Addendum Number # 1

Project Name: HCI Level 3 Lab Remodel

Project Number: 70509

HCI L3 Lab Remodel [70509 / 5171927]
Pre-Bid Meeting Questions

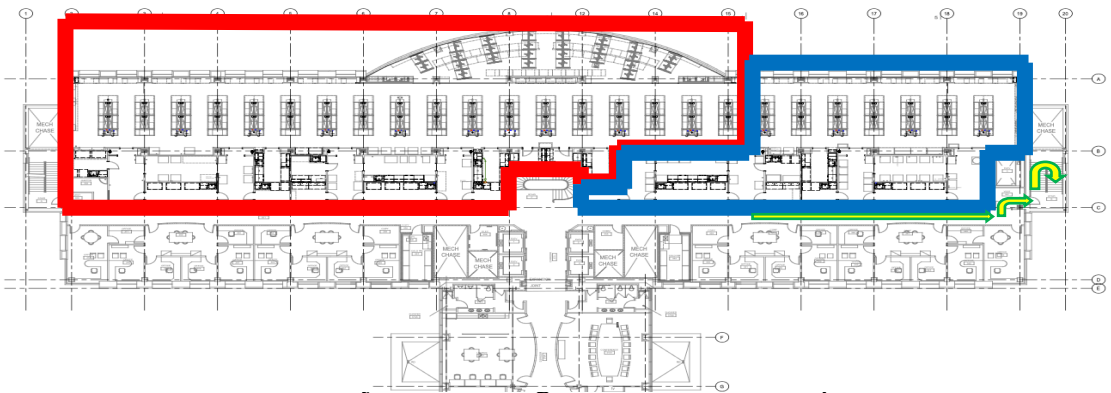
1. What is preferred travel path for materials & waste?
 - a. See Below – Arrows (Yellow/Green)
2. What is the phasing plan for construction?
 - a. See Below
 - i. Red = Construction Phase 1
 - ii. Blue = Construction Phase 2
